**Vinich Development
Commercial Development Plan**

Planning Commission Meeting
February 6, 2025
March 6, 2025

Case Number: 25.01 DEV

Vinich Development Plan – Lot 2A, Sage Addition

SITE PLAN FOR
LOTS 2 AND 3, SAGE ADDITION
 IN THE TOWN OF MILLS
 NATRONA COUNTY, WYOMING

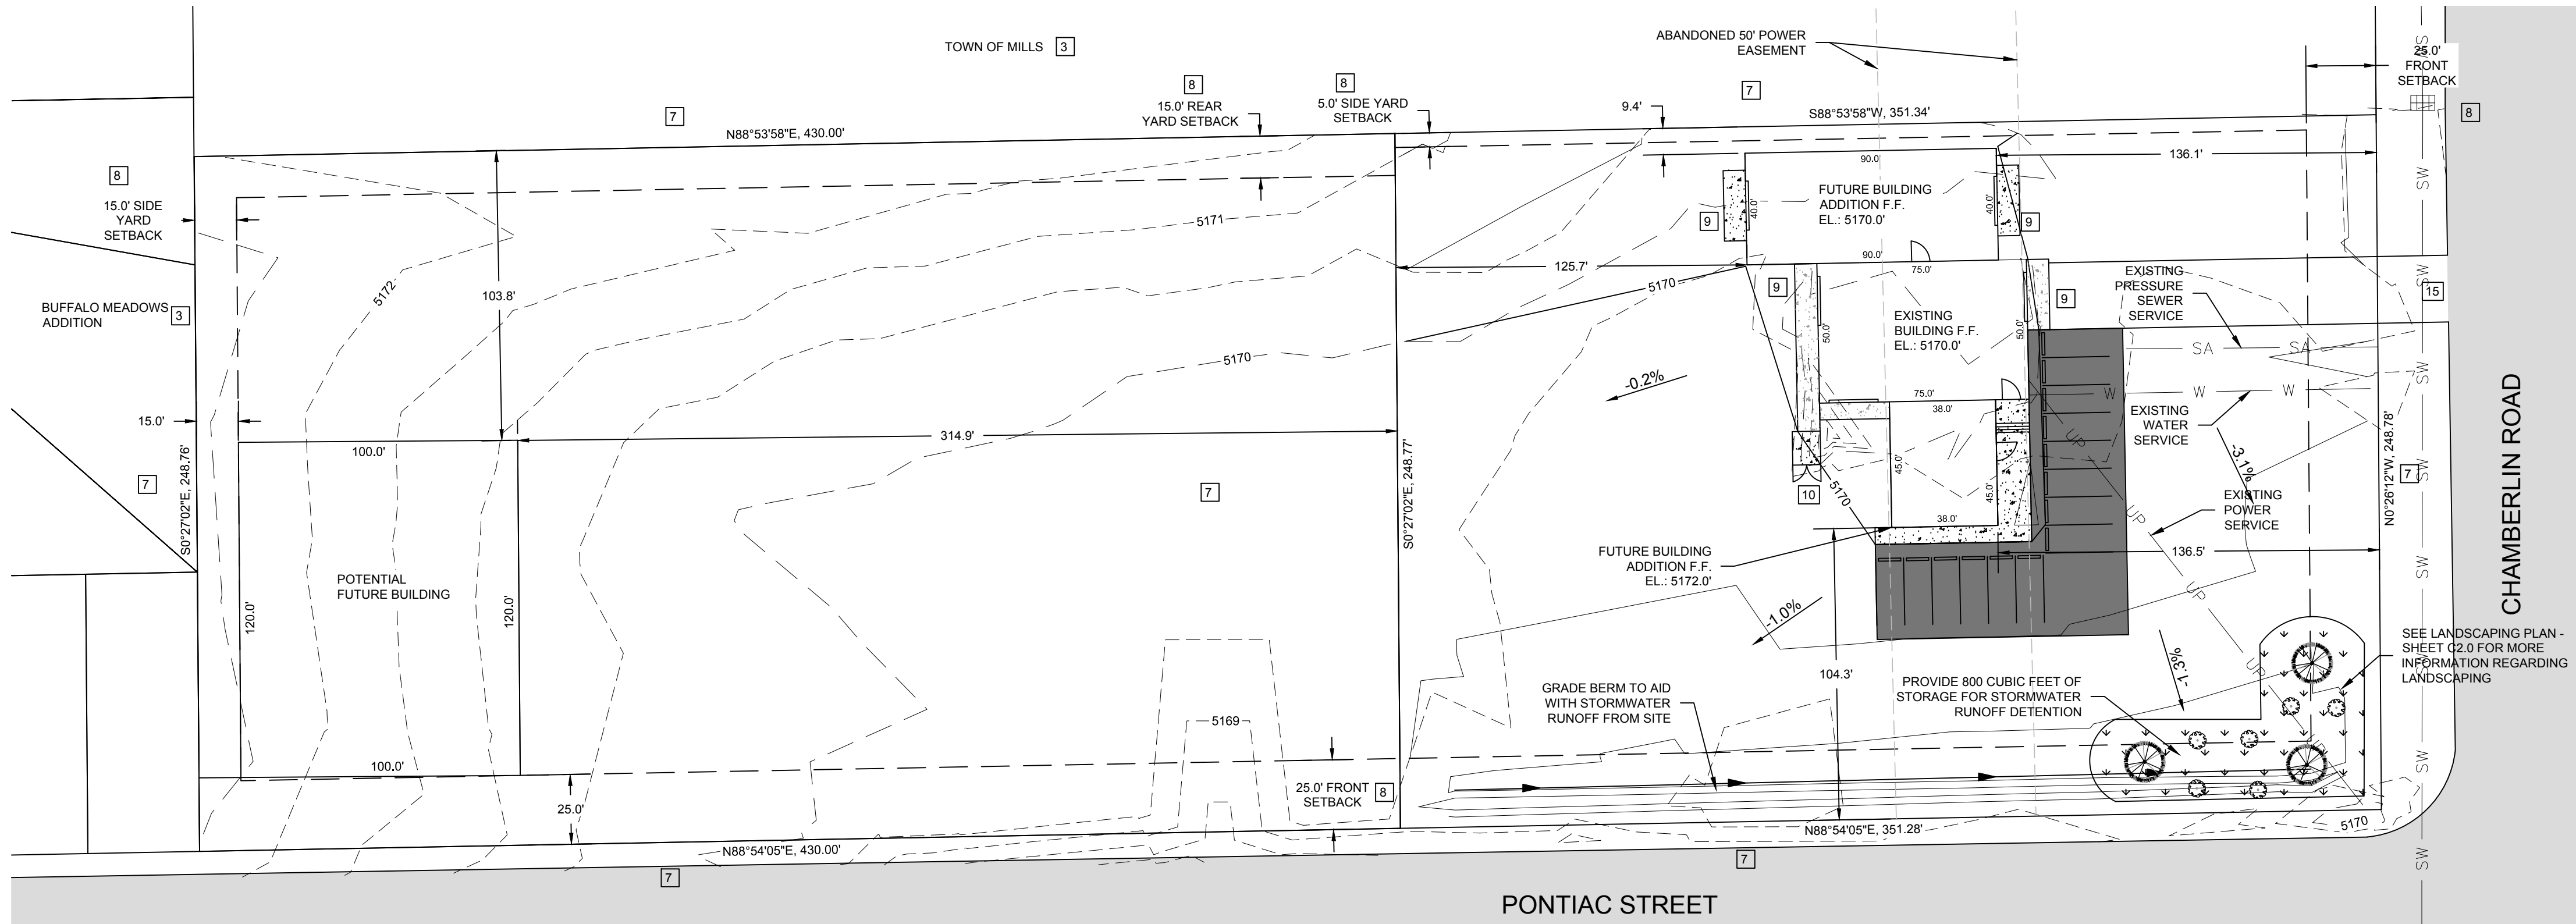
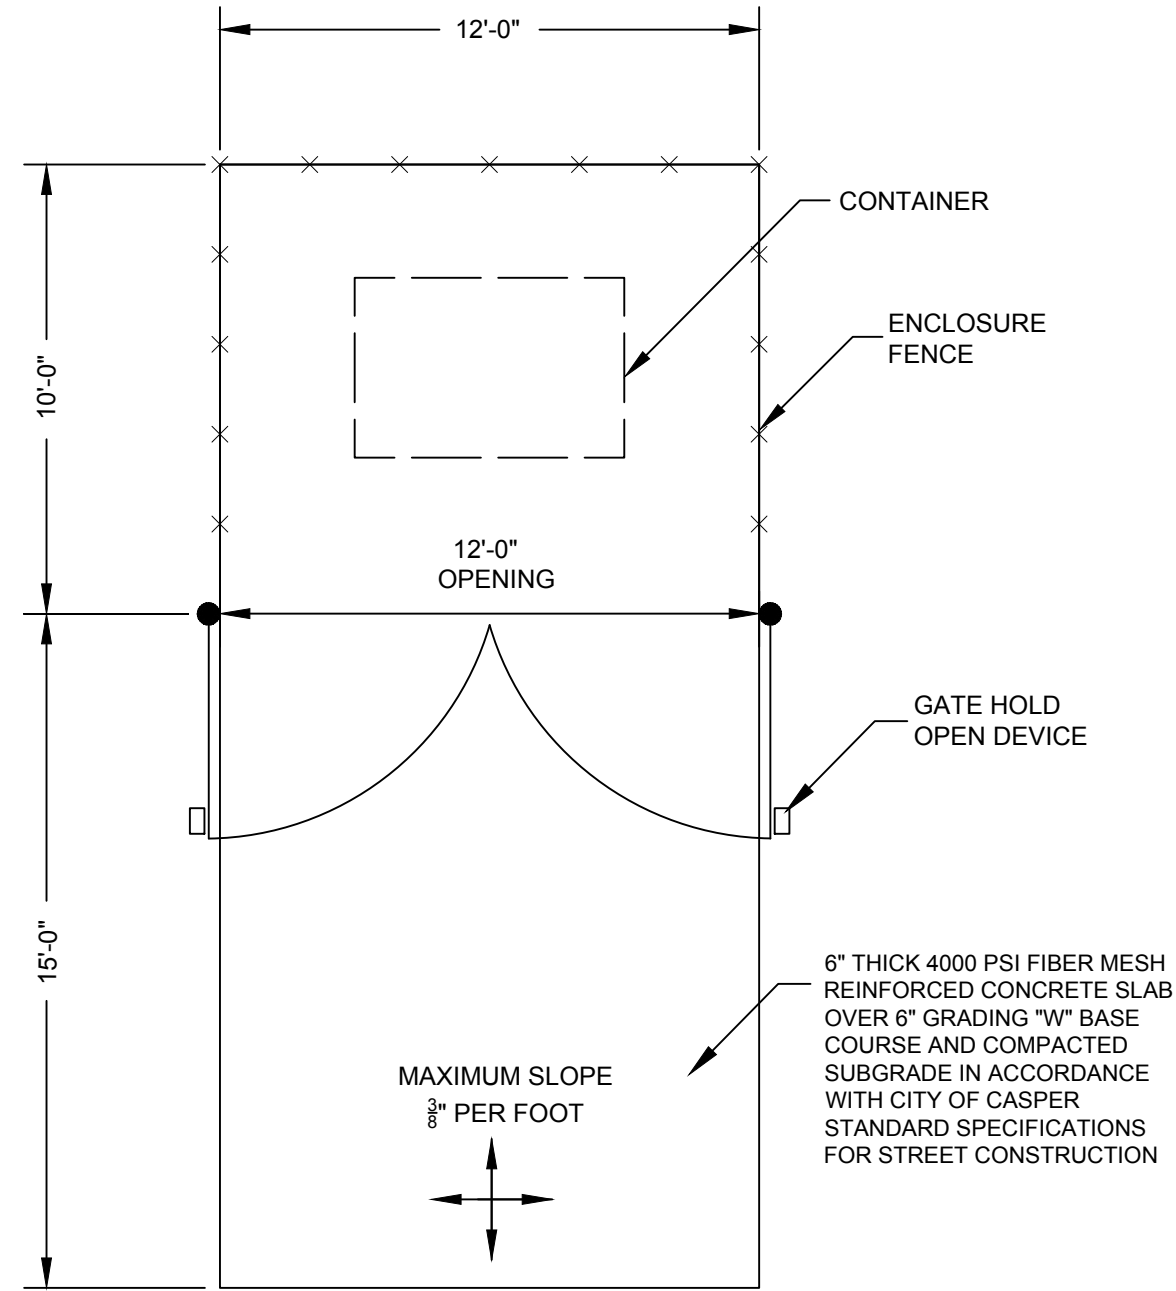
The development plan has been revised to show the location of the easement in relation to the existing and proposed structures. The existing structures are already constructed within the easement, however, for all intents and purposes, the easement is considered abandoned and its effect on future construction is negligible.

Per Section 40.40 of the LDRs, a minimum of 4% of the site must be landscaped. A landscaping plan for the property has been included with the submittal. The development plan notes that exterior lighting will be on the building, with no proposed parking lot illumination. Specifications for the types of exterior lighting for the building need to be provided.

1. Submit an exterior lighting plan per Section 40.35(4) showing the location and types of lighting for the building, along with manufacturer's specifications.
2. Per Section 40.10(6) all required parking spaces and all driveways, entrances and exits from the parking area shall be paved with asphalt, concrete or similar permanent surface.
 - a. Nine (9) parking spaces are required. 14 are shown on the development plan with asphalt surfacing. This meets the intent of the regulations.
3. Submit a final drainage plan
4. Show all existing easements on the site plan.
5. Enter into an approved Site Plan Agreement upon approval of the Development Plan.
6. Obtain all required building permits for:
 - a. All site lighting
 - b. All on-premise signage.
